APPEAL SUMMARY

Appeal ID: 16554	Project Address: 619 SW 11th Ave
Hearing Date: 2/28/18	Appellant Name: Jason Haden
Case No.: M-006	Appellant Phone: 971-202-4106
Appeal Type: Mechanical	Plans Examiner/Inspector: Jody Orrison, Thomas Ng
Project Type: commercial	Stories: 15 Occupancy: R-1, A-2, A-3, B, S-1 Construction Type: 1A (constructed to 1B for fire resistance req's pe
Building/Business Name: Hyatt Centric Portland	Fire Sprinklers: Yes - Fully sprinklered
Appeal Involves: Erection of a new structure	LUR or Permit Application No.: 17-265447-CO
Plan Submitted Option: pdf [File 1]	Proposed use: Commercial - Hotel

HYATT CENTRIC

**GUESTROOM
ENTRY SOFFIT**
NOT TO SCALE

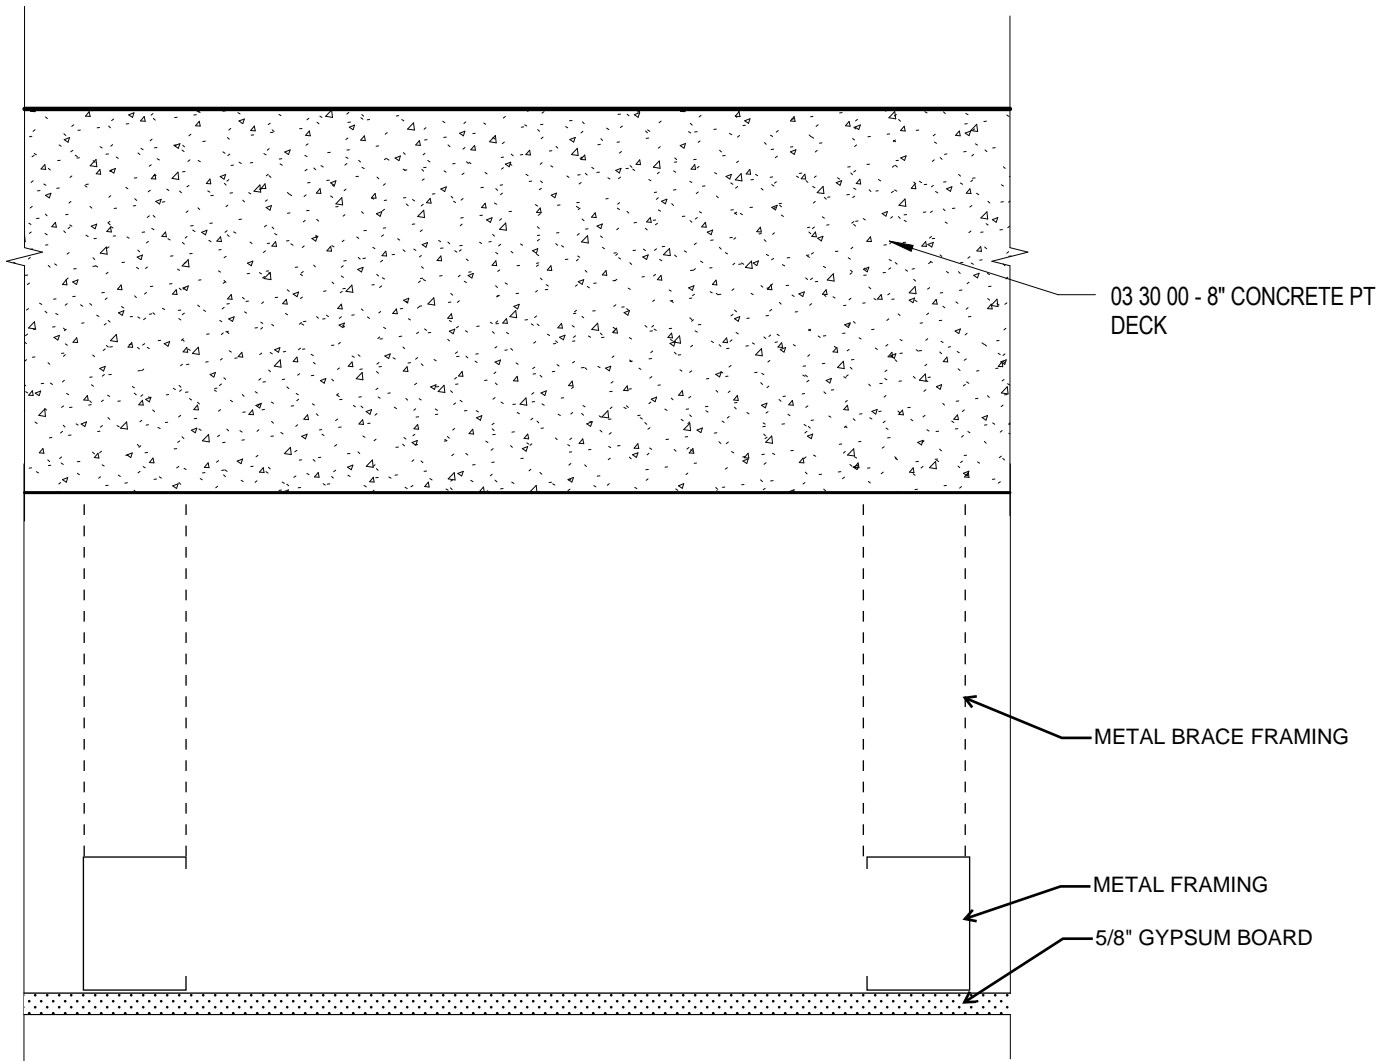
Proposed Design The fan coil unit is in a ceiling soffit with limited access. An electrical access panel adjacent to the fan coil will provide ample access to change the filter, access the control panel and refrigerant line connections to the unit. This width of the electrical access panel will either be 30" or the width of the equipment, whichever is larger by 36" deep. In the case for this property, a 70" x 33" access panel would be needed to completely remove the unit. A panel of this size is unsightly and negatively impacts the guest experience.

In the rare event that the fan coil unit needs to be removed from its location, a portion of gypsum board will be demolished, the unit replaced and the ceiling patched. As neither the Owner nor the design team believe the gypsum board ceiling should be considered "permanent" construction as at some point in time the fan coil will need to be replaced. It should also be noted that the life cycle and expectancy, as documented by Mitsubishi, is 20 years.

The Owner of the building is requesting this appeal due to the abnormally large access panels (70"x33") that will be required in the gypsum board ceilings. The Owner feels that this access panel will negatively impact the guest experience and may impact revenue. The Owner understands the importance and requirements of the electrical access panel but does not share in the interpretation of OMSC 306.1. There are multiple cases of similar hotel properties within the Portland area that have true maintenance access panels (24"x24") and those properties have assumed the financial risk of full and/or partial ceiling replacements should the fan coil unit fail.

Mechanical equipment access: Hold for additional information.
Appellant may contact John Butler (503 823-7339) with questions.
